L Usine Fashion Ltd. (Extension)

18 January 2024

2. Observations

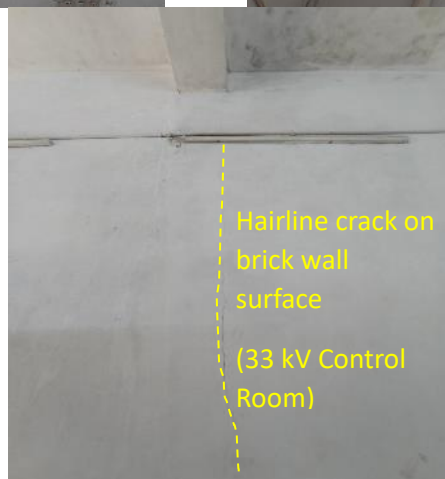
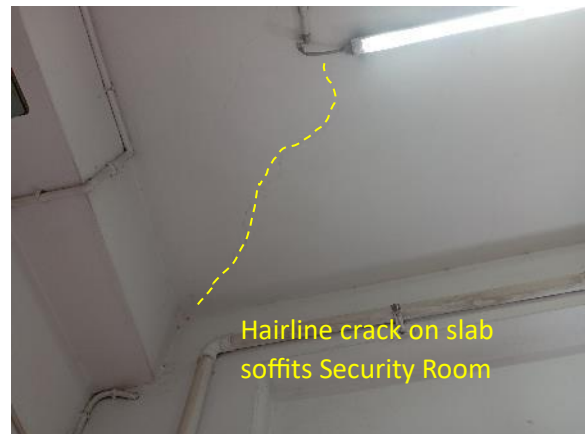
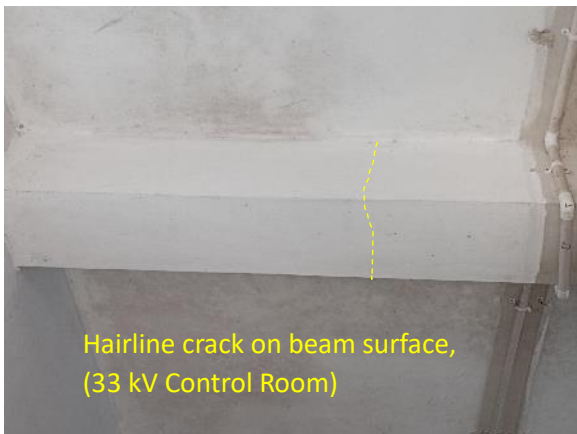
Observation-1: Lack of lateral stability of steel roof (Steel Building).

Description: No roof bracing is provided for the shed. The building engineer is required to check the lateral stability of the roof structure and propose a remediation plan.

Observation-2: Hairline crack on beam, slab, and brick wall (Security Room, 33 kV Control Room)

Description: Hairline crack was found on beam, slab, and brick wall surface. The building engineer is required to investigate the cracked areas and repair the crack with a suitable method.

Observation	Action Plan	Timeline
Steel Building		
Lack of lateral stability of steel roof (Steel Building).	The building engineer is required to check the lateral stability of the structure and revise the design report following BNBC-2020 with necessary remedial actions. Submit revised design documents to the RSC for detail review.	within 6 weeks
Lack of lateral stability of steel roof (Steel Building).	Implement remediation work if required.	within 6 months
Security Room, 33 kV Control Room		
Hairline crack on beam, slab, and brick wall (Security Room, 33 kV Control Room)	The building engineer is required to investigate the cracked areas and repair the crack with a suitable method.	within 6 weeks
